# 1968 Corvette: Service News: Corvette Folding Top Compartment Lid to Folding Top Interference (SN-68-20)

**Subject:** Corvette Folding Top Compartment Lid to Folding Top Interference (SN-68-20)

**Model and Year:** 1968 Corvette

**Date:** April 1968, Volume 40, Issue Number 4

**Fig. 12—Remove  $\frac{1}{8}$  " From Lid Stops**

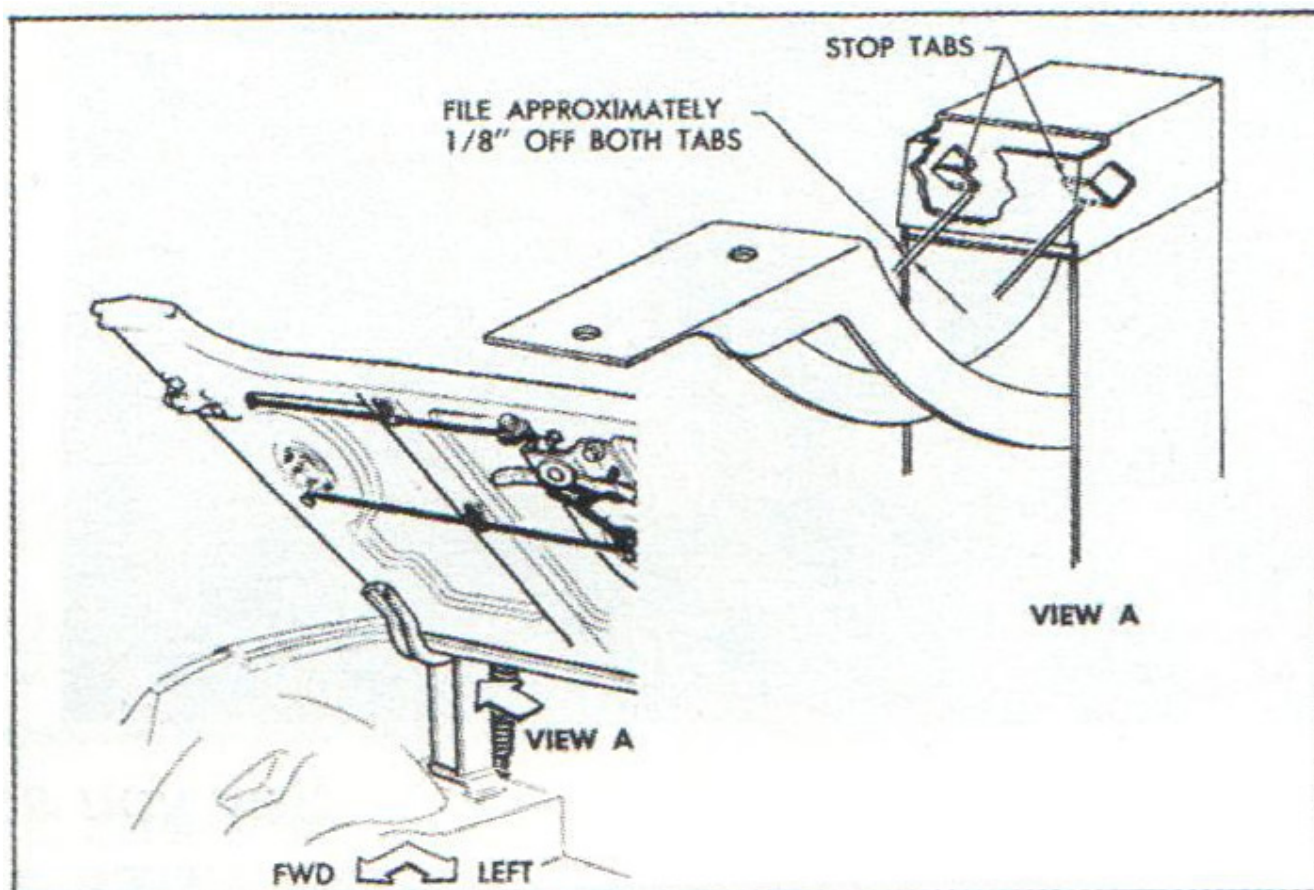
It has been found that the rear compartment lid on some 1968 Corvettes interferes with the convertible top when the top is being raised or lowered. This interference is easily eliminated by filing approximately 1/8" off the existing hinge stops (right and left side). Removing 1/8" from the hinge stops, as shown in Figure 12, allows the rear compartment lid to raise farther thus eliminating the interference condition. The stops referred to are simply tabs that has been punched out of the hinge support members.
